Product Change Notification
Software Release Notice

MultiTech® Conduit®
Family of Programmable Gateways:
Conduit IoT Programmable Gateway
Conduit IP67 Base Station,
and Conduit AP Access Point

mPower™ Edge Intelligence
mPower 5.2.X Firmware Available

Product Change Notification Number
PCN 06022020-001

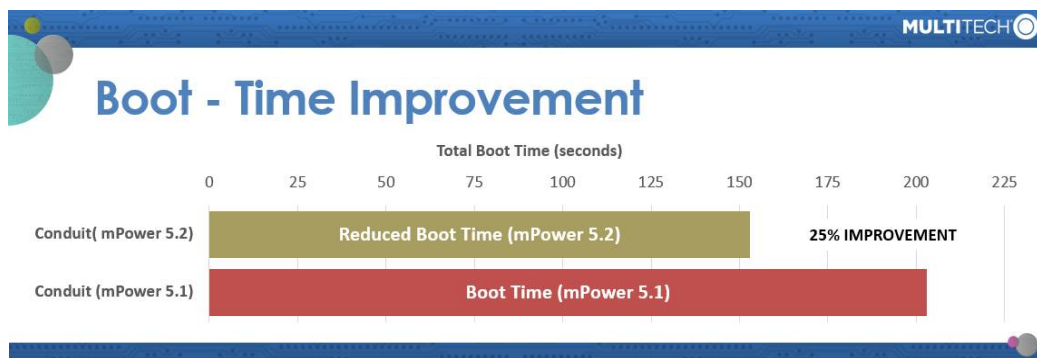
1. **Reduced Boot Time** Previous versions of mPower resulted in longer boot times. mPower 5.2.X includes new features and optimization that decrease the device boot time up to 25% [GP-256, GP-360, GP-362, GP-363, GP-364]

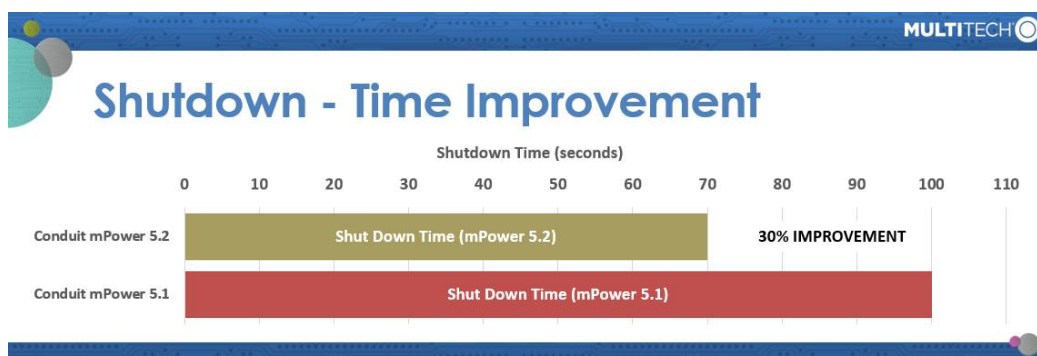
2. **Shutdown Time Optimization:** When restarting a device, the total time to reboot also includes shutdown time. Previous versions of mPower resulted in longer shutdown times. mPower 5.2.X has been updated to reduce shutdown time. Conduit mPower shutdown time has been shortened by 30%.

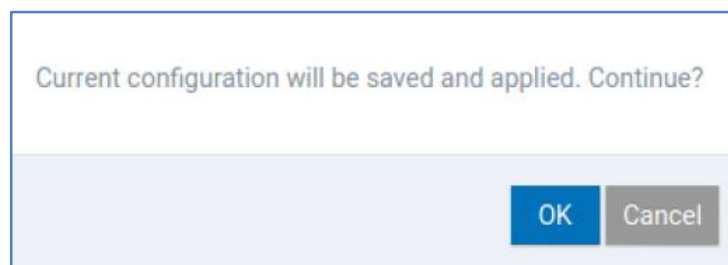
3. **Save and Apply Configuration Settings without Restarting:** Previous versions of mPower required a device reboot for most system configuration settings. mPower 5.2.X has been updated to save and apply many configuration settings without the need to restart. In these cases, the user will be presented a “Save and Apply” button after making configuration settings. If “Cancel” is selected, changes are not saved. [GP-339]

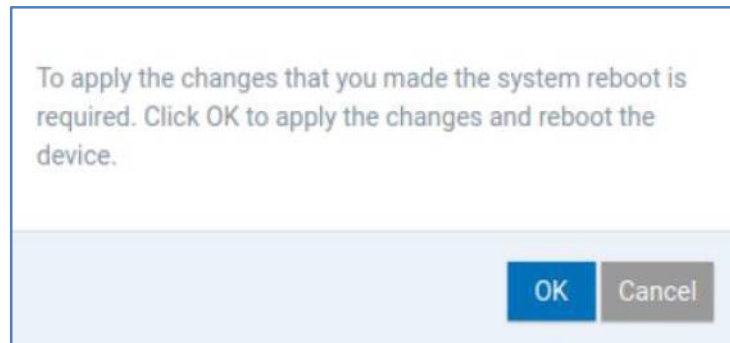
A limited number of system configuration setting changes will still require the device to be restarted. In these cases, the user will be presented with a “Save and Reboot” button after making configuration settings. If “Cancel” is selected, changes are not saved.
